Design Review Subcommittee (DRSC)

Meeting Date: August 24, 2016

SUBJECT: **Sign Exception Permit 15-428, Amendment to Discretionary Sign Permit 05-176 and Administrative Sign Permit 16-128 Outlets of San Clemente Freeway Oriented Signs**, a request for 23 freeway oriented tenant signs and three project Identification signs, 20 of which are over 64 square feet for the Outlets at San Clemente, located at 101 West Avenida Vista Hermosa.

Table 1 – Proposed Freeway Oriented Signage

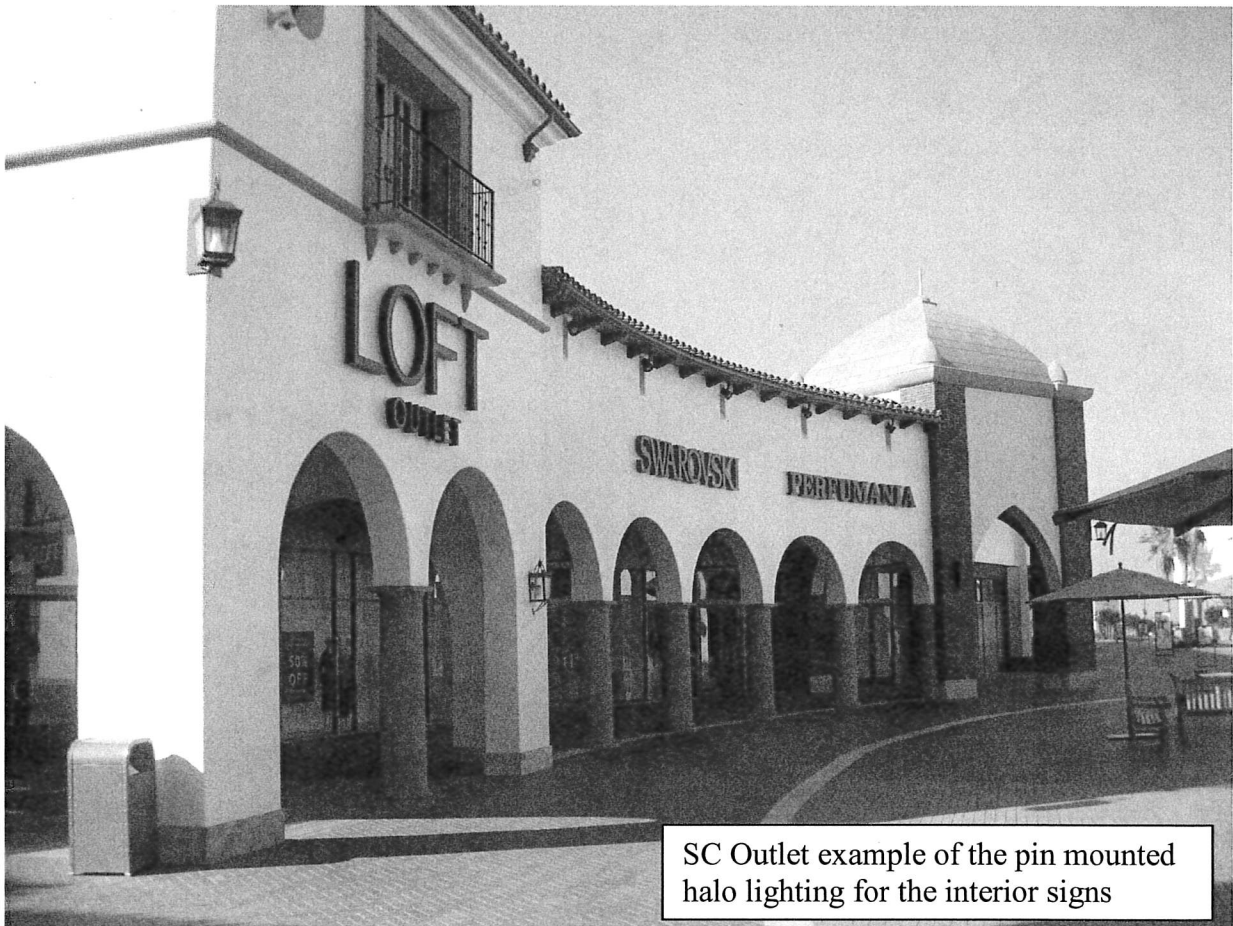
SC Outlet example of the pin mounted halo lighting for the interior signs

Sign # 3 location impacts the character of this architectural feature

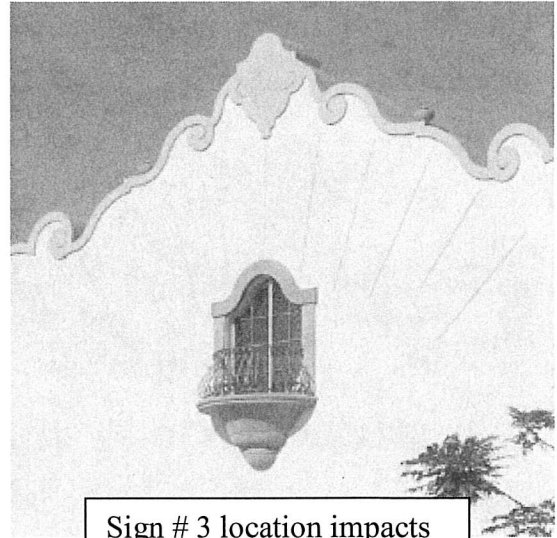
2. Sign Locations

Careful placement of signs on a building can accentuate the building design. The majority of the sign placements proposed are on open wall areas where the signs placement is complimentary to the building architecture. The placement of signs 3, 21 and 22 however are located on building features where the placement of signs in these area detract from the buildings architectural design and should be eliminated.

- #s 3, 21 and 22 should be eliminated because the conflict with architectural features.
- Sign program should prohibit the allowance of freeway oriented banners in the future.
